PANEL ASSESSMENT BRIEFING REPORT
SYDNEY WESTERN CITY PLANNING PANEL

PANEL REFERENCE & DA NUMBER	PPSSWC-560 – DA-225/2025 (PAN-527180)
PROPOSAL	Demolition of all existing structures, selective retention and removal of existing trees, earthworks, site remediation, construction of a neighbourhood shopping centre comprising of a full line supermarket, liquor store, 15 retail units (cold shell fit-out), 2 kiosks, food and beverage tenancy, car wash service, at-grade parking, loading facilities, landscaping, associated facilities, and business identification signage.
ADDRESS	95 Tenth Avenue, Austral Lot 1 DP 748006
APPLICANT	Mr Howard Hathorn, and Coles Group Property Developments Ltd
OWNER	Coles Group Property Developments Ltd
DA LODGEMENT DATE	13 May 2025
APPLICATION TYPE	Development Application
REGIONALLY SIGNIFICANT CRITERIA	Clause 2, Schedule 6 of the State Environmental Planning Policy (Planning Systems) 2021
CIV	\$50,007,000 (excluding GST)
CLAUSE 4.6 REQUESTS	No 4.6 Variation proposed

PREPARED BY	Nabil Alaeddine Tamim Omar
DATE OF REPORT	27 May 2026

Figure 14: Zoning Map Extract

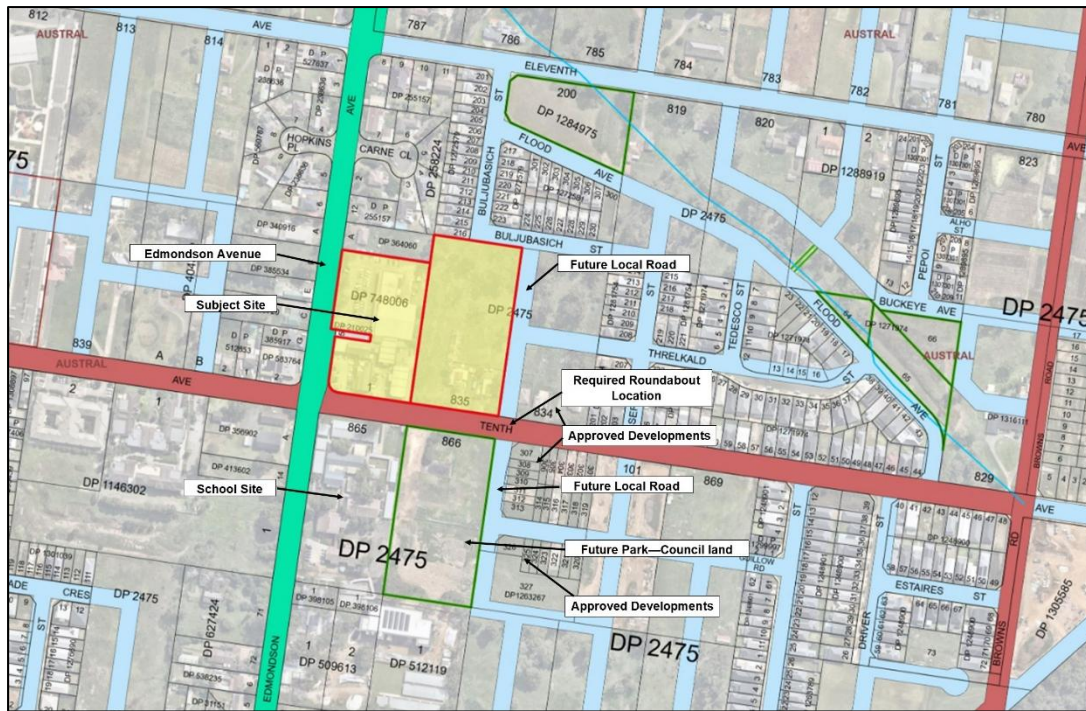
Issue: Council notes that under the Austroads Guide to Traffic Management, Part 4, indicates that a formal intersection treatment, likely a roundabout, will be required at the junction of Tenth Avenue, the future local road, and the future southern local road adjacent to the planned park and Council-owned land.

At the time of preparing this report, the applicant had not committed to constructing the roundabout. Council's Traffic Section considers this intersection treatment to be critical to the safe and efficient operation of the road network. The roundabout would significantly improve traffic flow, reduce vehicle–pedestrian conflict, and enhance safety for school children, particularly given the expected expansion of Austral Public School and the associated increase in student numbers.

Comments: The requirement for a roundabout at the intersection of Tenth Avenue, the future East Road, and the future South-East Road has been consistently identified as a critical piece of infrastructure necessary to support the safe and efficient operation of the neighbourhood centre at 83 Tenth Avenue. The roundabout is required to manage increased traffic volumes generated by the development and to ensure safe vehicle movements within the future road network.

While the applicant has acknowledged the need for the roundabout, they have not formally agreed to design or construct this infrastructure as part of the current development application. Notwithstanding this, the development is dependent on the roundabout to ensure appropriate traffic distribution, safe access, and compliance with Council's road hierarchy and network planning.

The applicant has suggested that Council could construct the roundabout; however, the roundabout is not identified or funded under Council's Contributions Plan. As a result, if the developer does not agree to deliver the roundabout in conjunction with the proposal, there is a significant risk that the infrastructure may never be constructed, which would in turn create long-term traffic and safety issues for the surrounding road network.

To ensure the road network functions safely and effectively, a condition of consent is recommended requiring the applicant to design and construct the roundabout, together with the associated road connections, prior to the commencement of operation of the development. This condition secures the delivery of the infrastructure irrespective of the applicant's current position and ensures the development does not proceed without the necessary traffic upgrades in place.
